### **2016 UPDATE OF THE PADUCAH GASEOUS DIFFUSION PLANT SITEWIDE GROUNDWATER FLOW MODEL, DOE/LX/07-2415&D1**

**2016 Update  
of the Paducah Gaseous Diffusion Plant  
Sitewide Groundwater Flow Model**

**A Product of the Paducah Gaseous Diffusion Plant  
Site Groundwater Modeling Working Group**

Date Issued—March 2017

Figure 3.11. Land Use Assessment

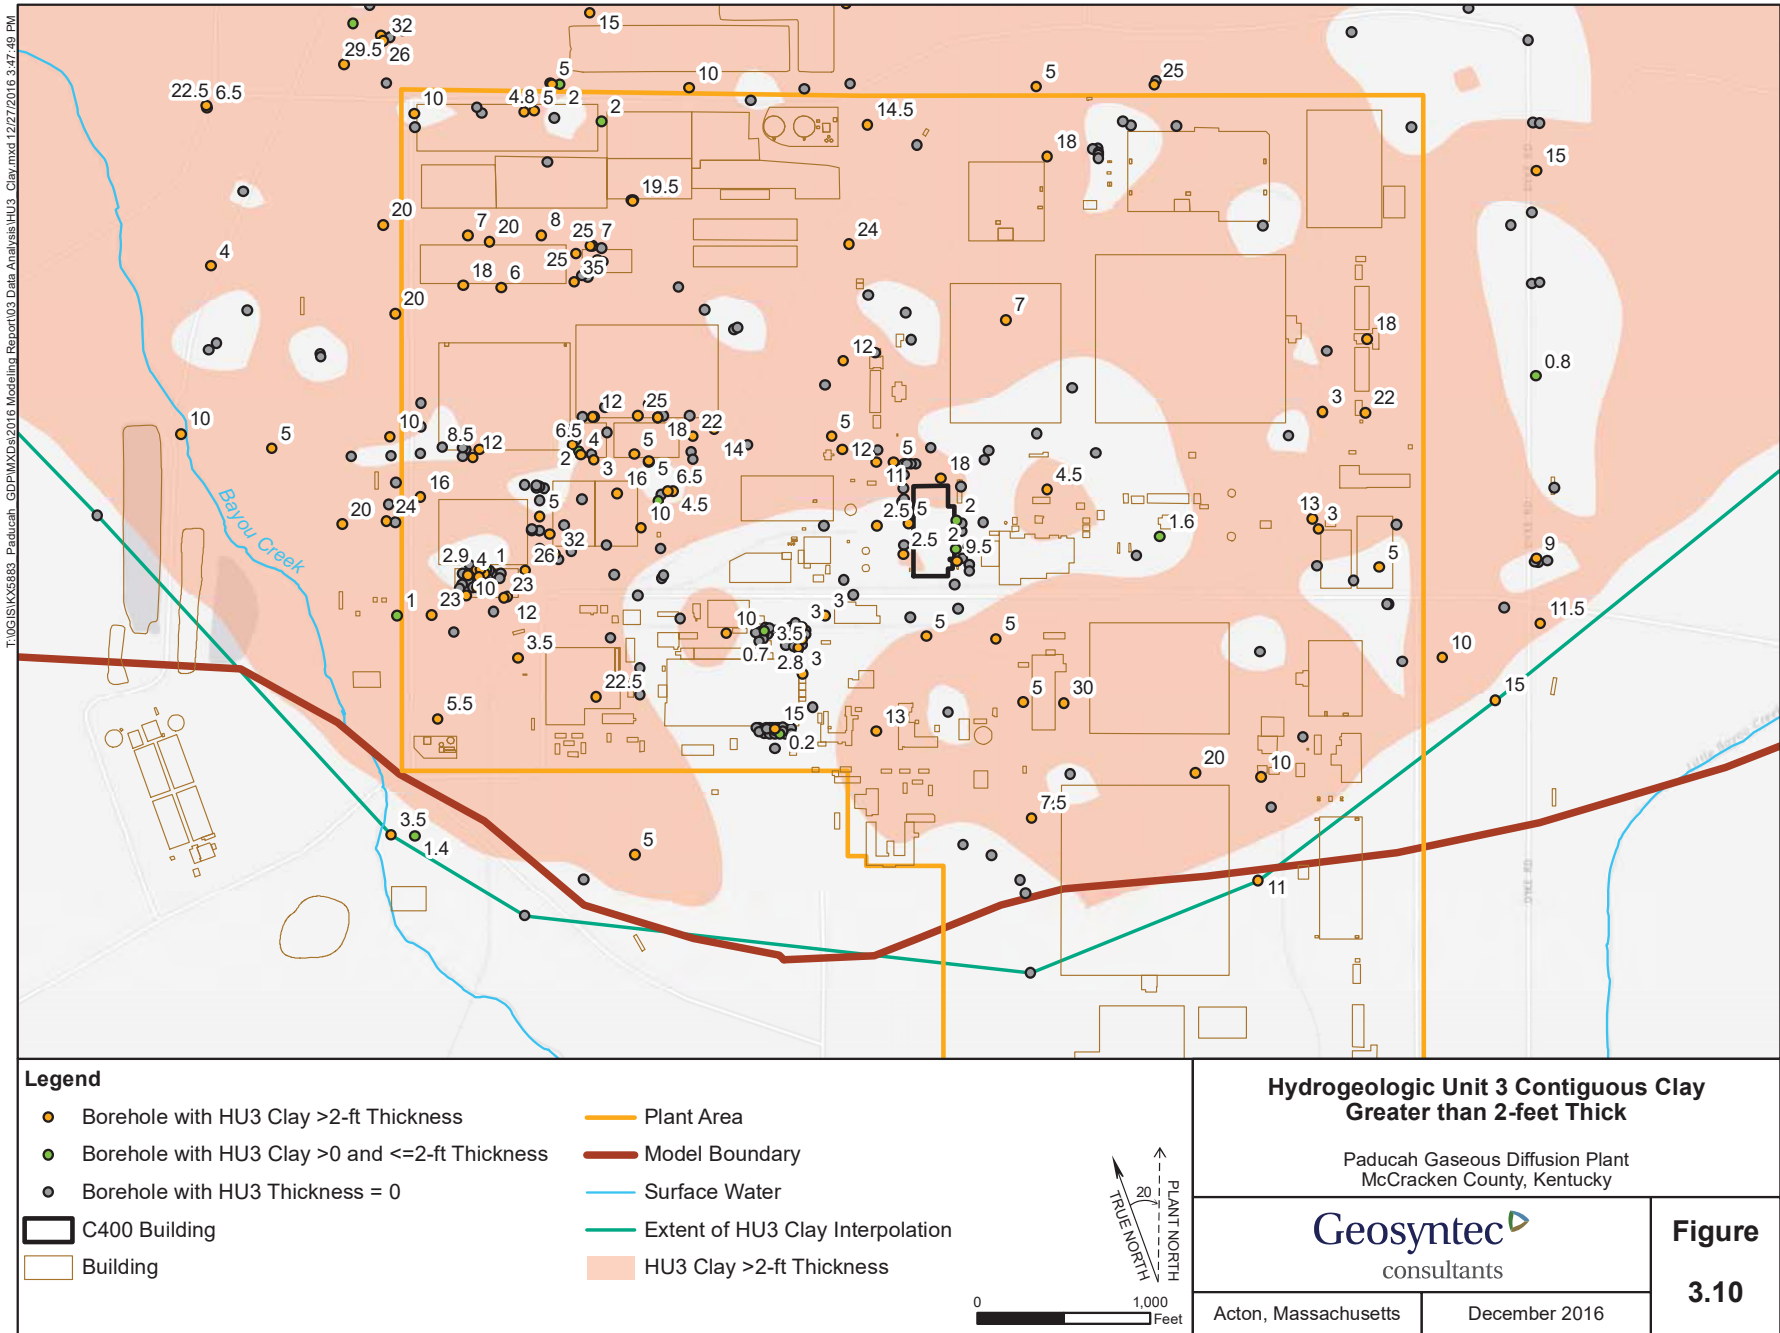
5. Pg-11: Figure 3.11 should be updated by incorporating the recent transect well data. Since the transect wells are located within the high recharge zone (Zone 24) with less than 2ft clay thickness, it is highly critical to include this data in the analysis.

Figure 5.5. Model Recharge Zonation in the Plant Area

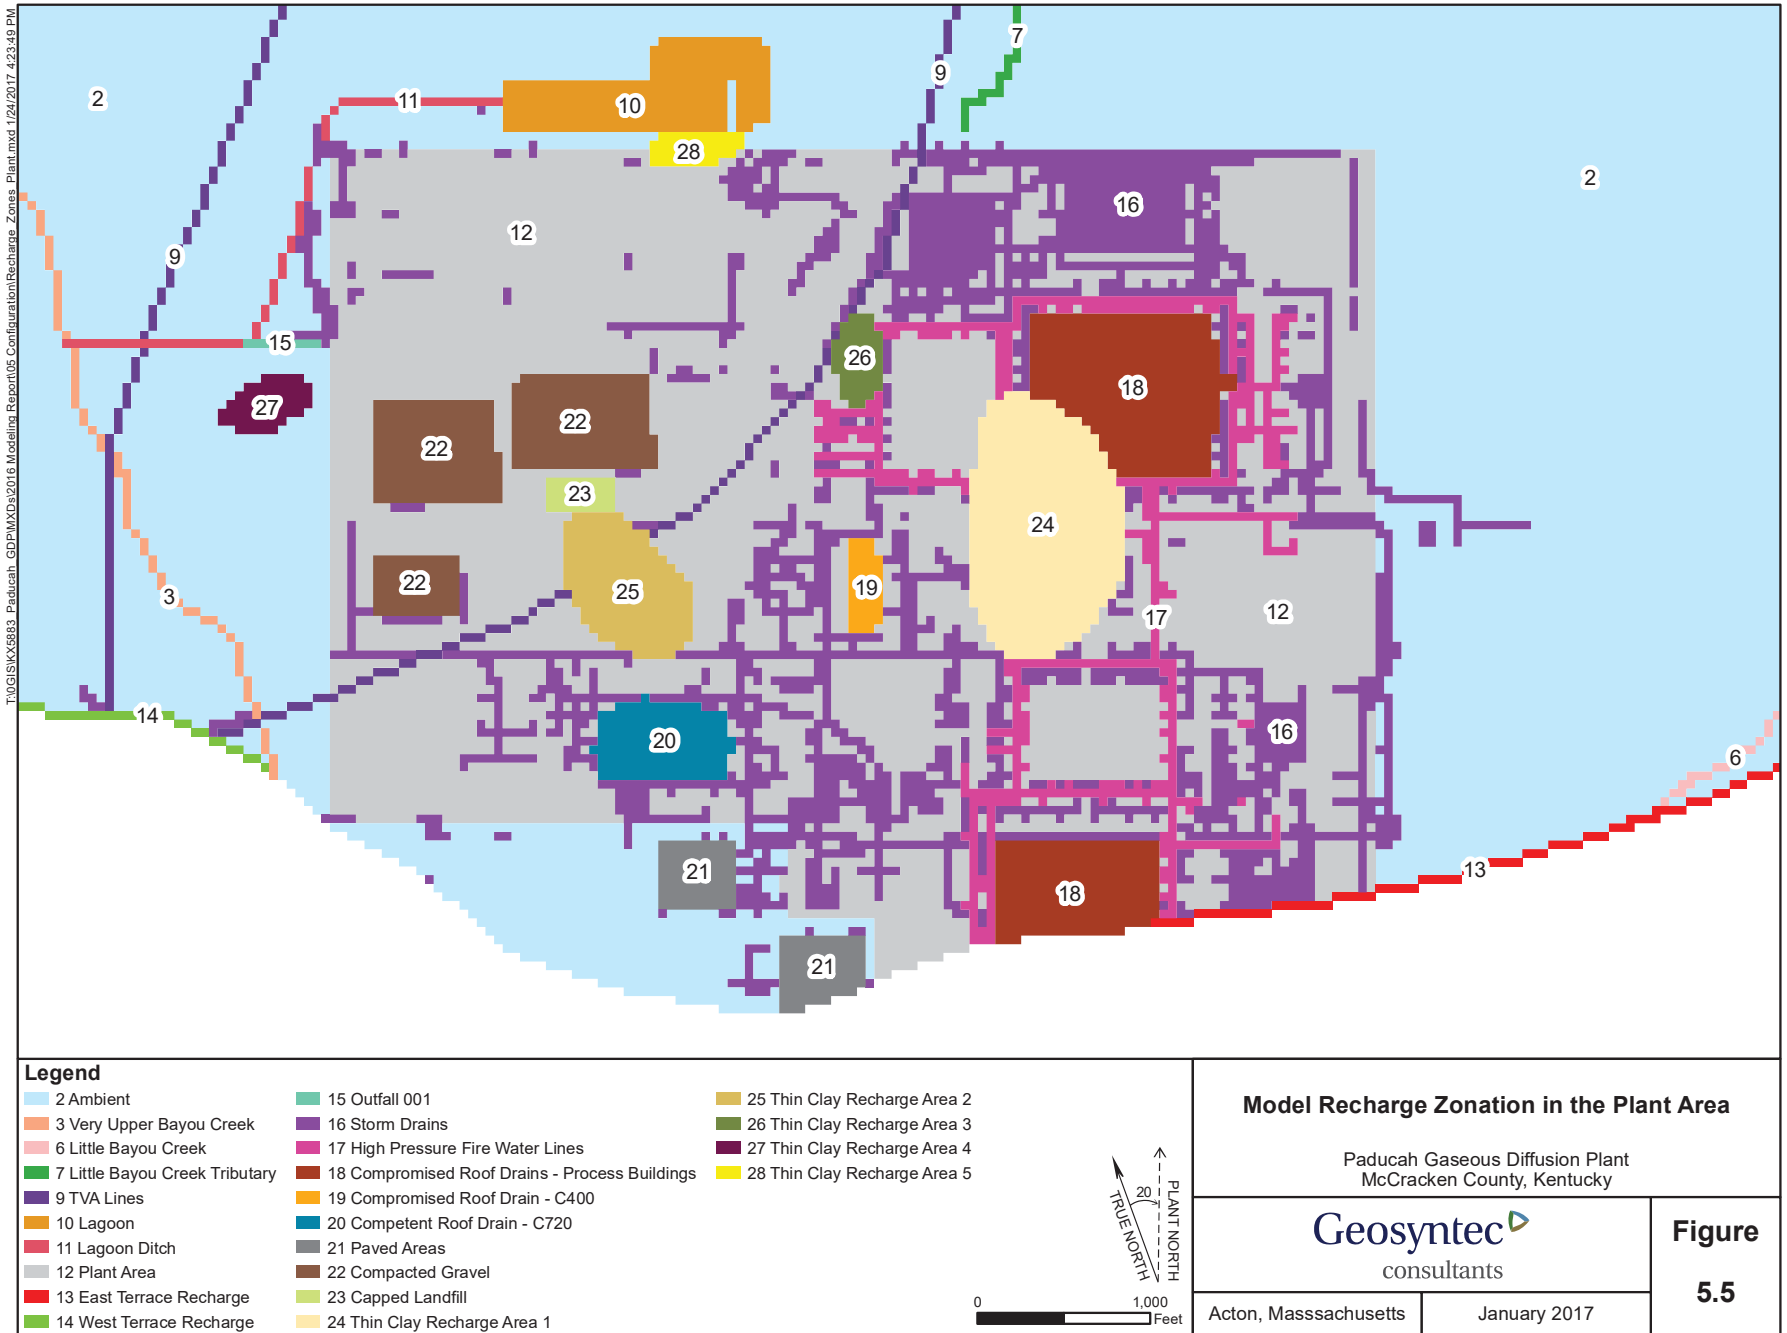
12. Pg-26: It does not look like the recharge zone for the storm drain (Zone 16) followed the footprint of the HU3 clay unit (see Figure 5.5 and Table 6.2).

Figure 6.9. Model-Predicted Potentiometric Surface and Water Level Residuals: Stress Period 1 (February 1995)

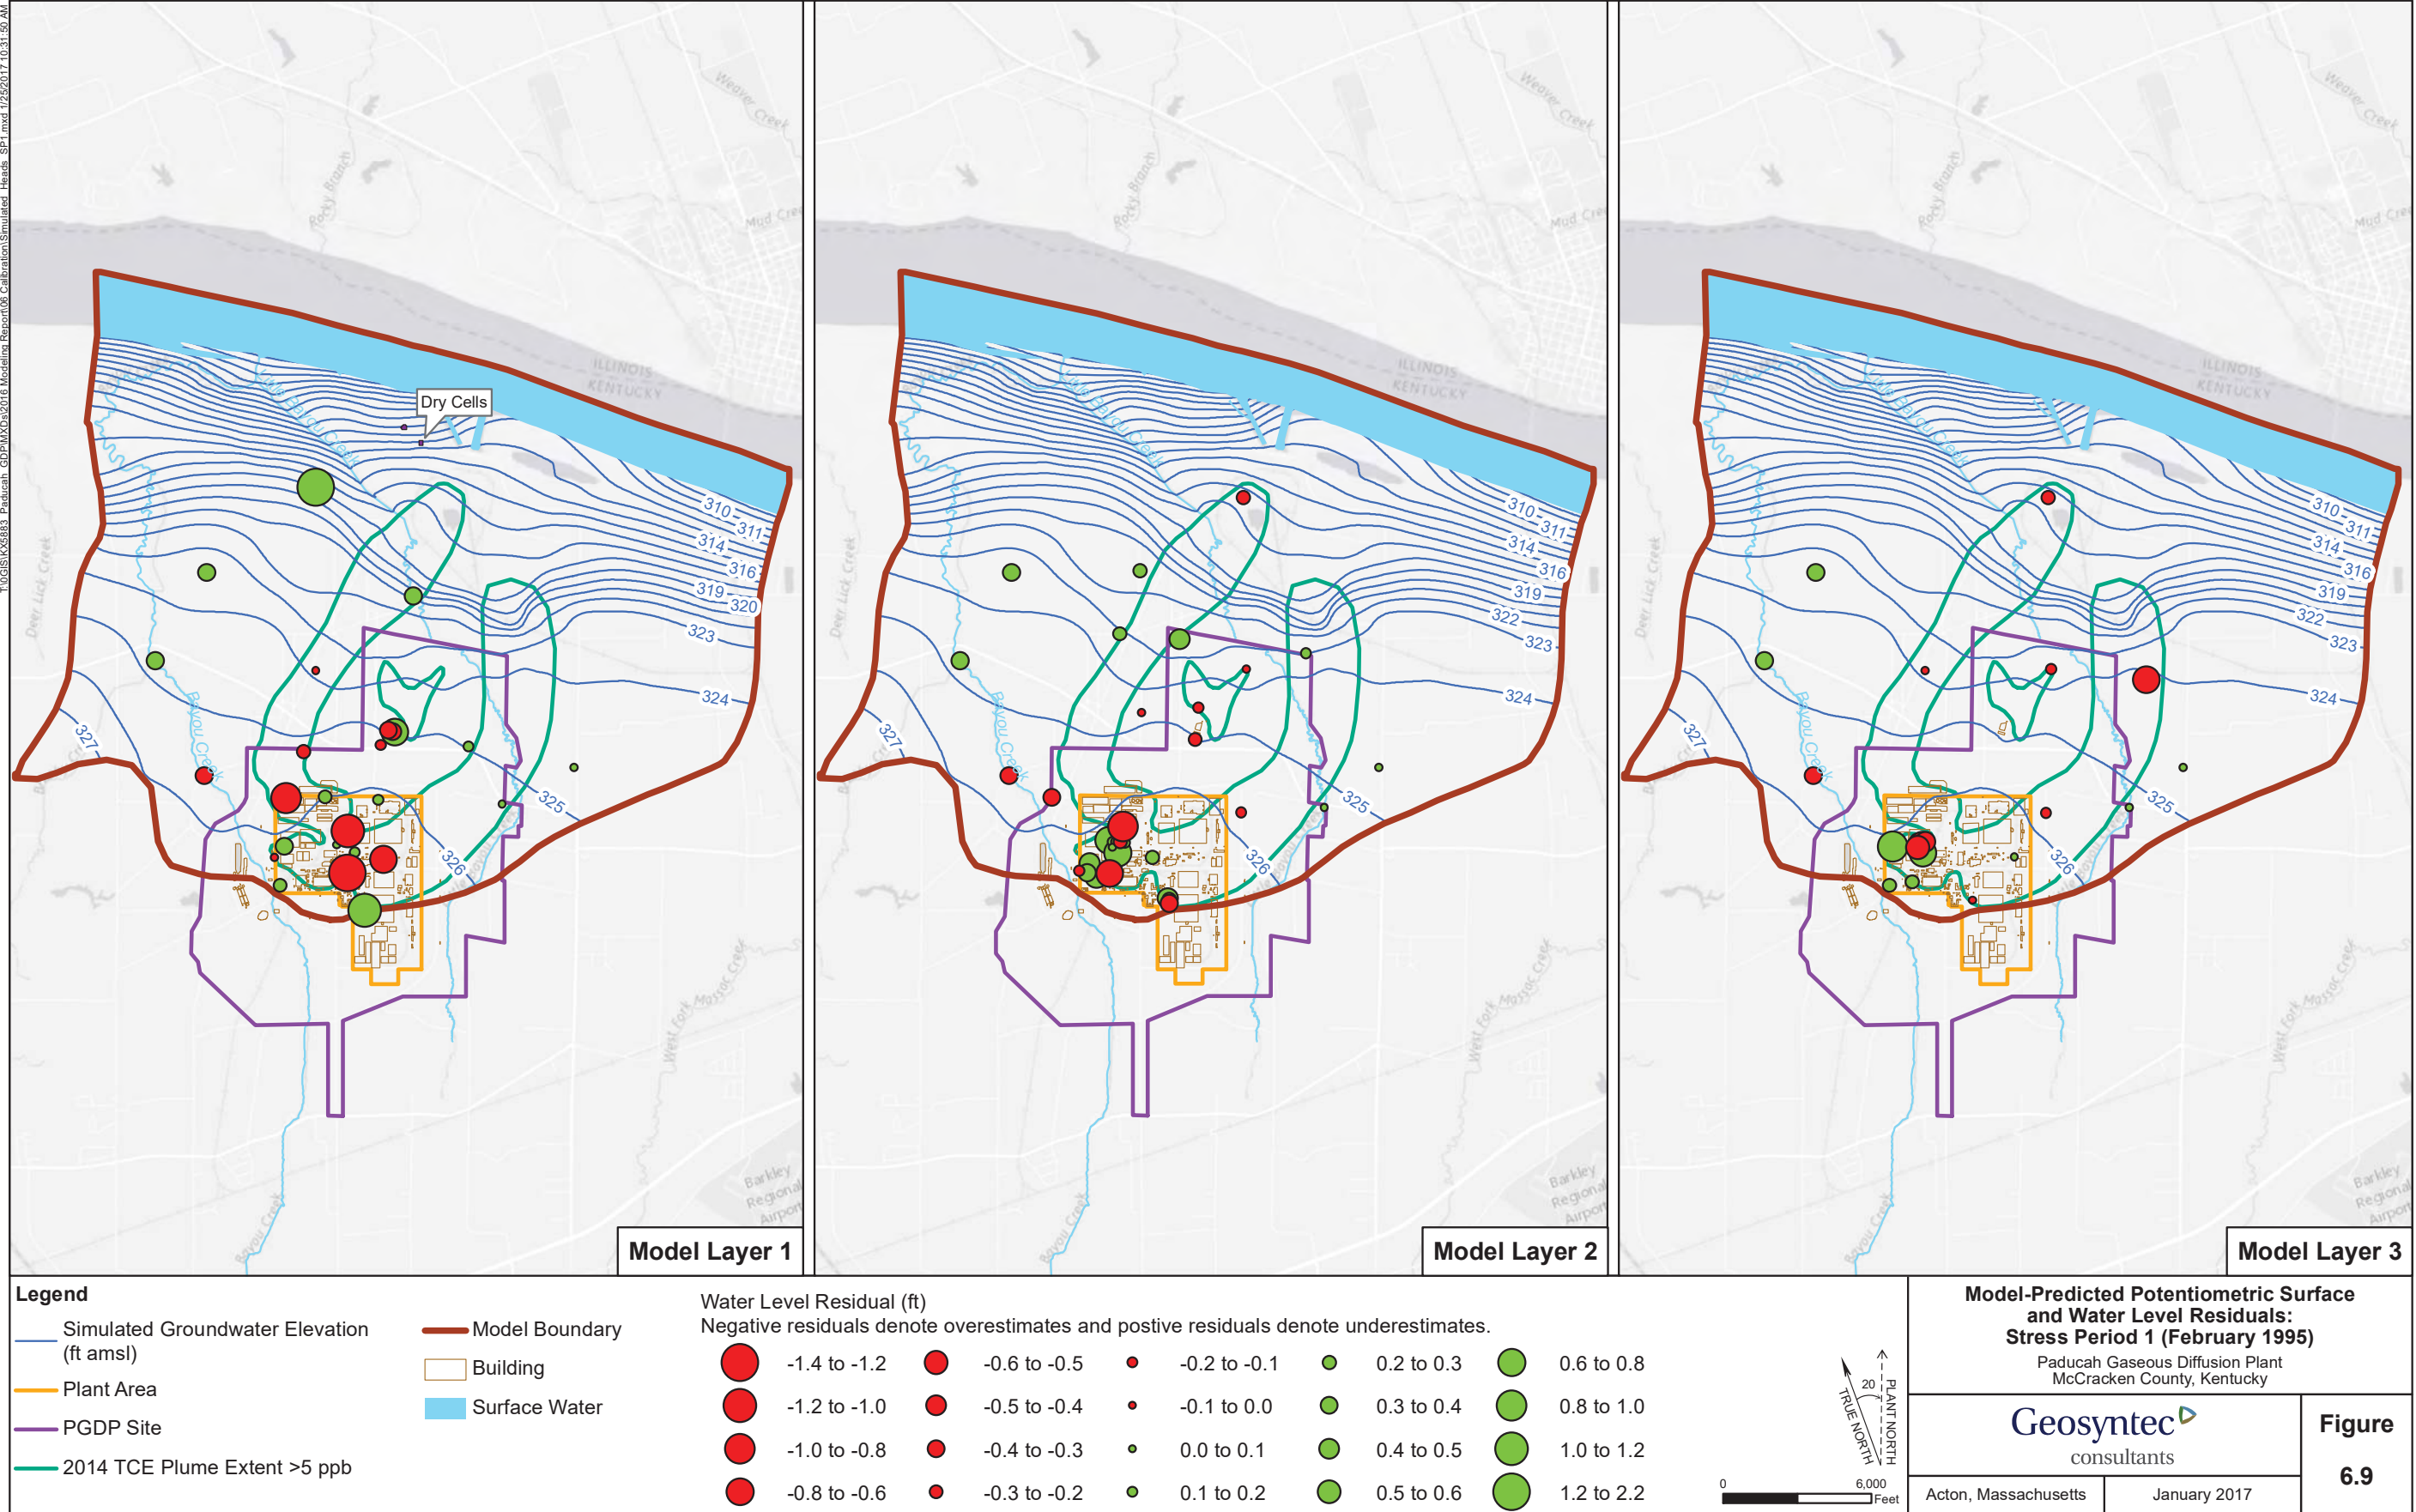
Noman Ahsanuzzaman asked if all water level targets are shown in Figure 6.9 of the report. He noted that more monitoring well locations seem to be shown on other figures. Denise Tripp responded that all wells that were used as targets are shown on the figure. Denise clarified that the figure divides the well set between the top, middle, and bottom model rows. She noted that fewer targets were available for stress period 1 and referenced Figure 6.10 to demonstrate that more targets were available for stress period 2.
